Environmental Review Team Report

Arnold Property

Killingly, Connecticut

ENVIRONMENTAL REVIEW TEAM REPORT
ON
ARNOLD SUBDIVISION
KILLINGLY, CONNECTICUT

Topography

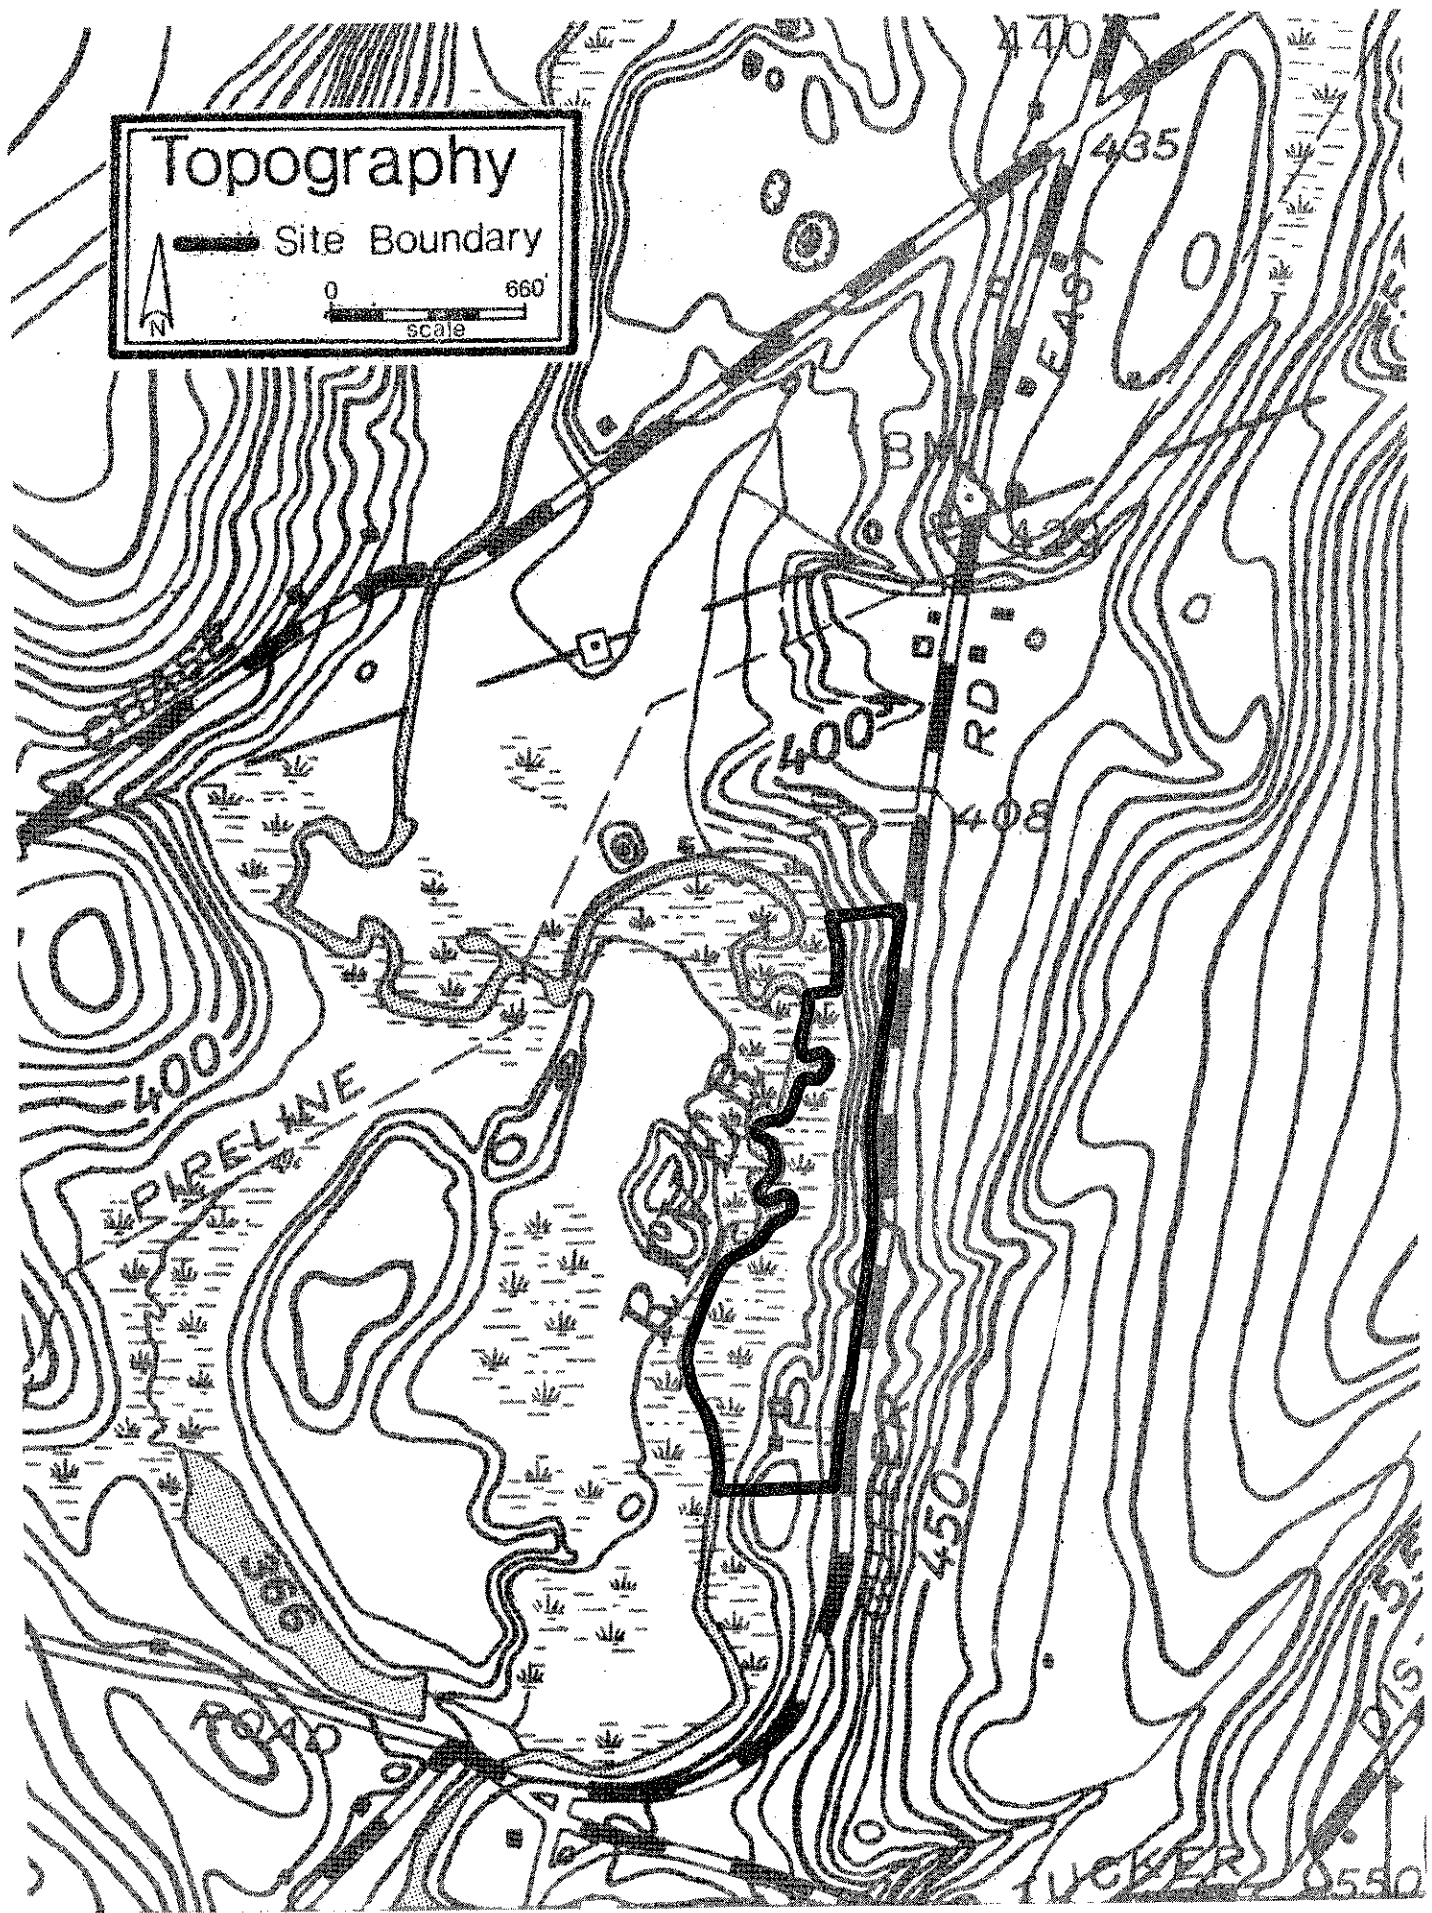
The major portion of the site has slopes in excess of 15%, which extend from Cutler Road to the wetland area associated with Five Mile River. Soils are well drained in most cases, except for those wetland areas. One drainageway crosses the site; in other instances, drainage or run-off from the street occurs by sheet-flow across the site. The area is moderately vegetated with sparse groundcover in the upland areas and more dense plant populations near the wetland areas. Hartford Fern, a rare and endangered species, was noted in the vicinity of Lot #2.

Severe slope, generally in excess of 15%, is the greatest limiting factor to development of this site. The slopes are well adjusted to the present sheet-flow system of run-off discharge; however, soil disturbances such as the cuts and fills needed for construction on this site will alter this natural balance, causing problems with erosion and sedimentation. These problems may also be aggravated by creation of impervious surfaces on the site, which will increase the volumes of run-off. There may also be a potential for well contamination due to the proposed well locations down slope of the septic systems. Team sanitarians recommend that engineered septic systems be required in this subdivision due to the extreme topographic conditions and space constraints on the site. Special zoning permits will be necessary for building to occur on these proposed lots, due to excessive slope and need to comply with setback requirements from Cutler Road.
